- 1 In consultation with representatives of the Residents for Responsible Development Cromwell group on the proposed Plan Change 14 application following the hearing, the proposed Structure Plan has been revised, refer to Rev A (dated 14 July 2020).

## Evidence in Reply

Figure 1: 22 July Indicative Master Plan RLA1, 2, and 3 Lots on the Farmland Terrace

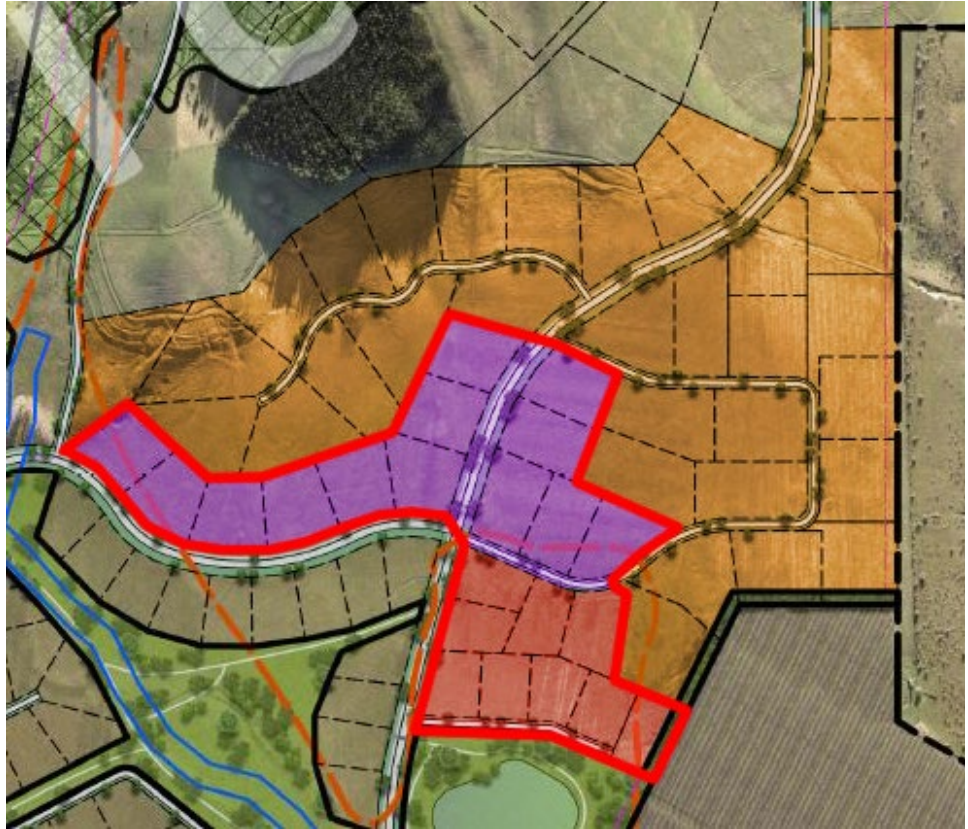
- 8 To the north of the loop road, a new area of RLA2 has been introduced on the lower slopes of the 'Farmland Terrace'. This increase in density of the lower 'Farmland Terrace' contributes to a more blended transition across the RLAs. In the previous version of the Structure Plan and Indicative Master Plan (26 May), the smaller lots sizes (RLA1 and 2) were contained to the flat core of the site with medium (RLA3) lots on the terraces and large lots (RLA4 and 5) on the slopes/SAL. The expansion of the RLA1 and addition of the north RLA2 has extended the concentration of smaller lots from the flats onto the lower slopes of the 'Farmland Terrace'.

- 9 The increase in density on the 'Farmland Terrace' between the stormwater corridor and SAL includes 1.97 ha of RLA1 and 3.97 ha of RLA2. This area, a total of 5.94 ha, was included within RLA3 in the previous iteration of the Structure Plan and Indicative Master Plan. Based on area, this would accommodate 14 lots of 4000 sq m (RLA3). The amended Structure Plan and Indicative Master Plan in its current layout, allow for 9 lots of 2000 sq m (RLA1) and 13 lots of 3000 sq m (RLA2). This demonstrates a total increase of eight allotments, depending on subdivision layout.

- 10 On the whole, this increase of approximately eight lots and the associated increase in density in this area of the site, is not viewed as a significant change in the context of the overall scale of the proposal, and as the proposed elements are of a rural character (rural roading, materials, colour, built-form, etc.), the development will still deliver a rural outcome.
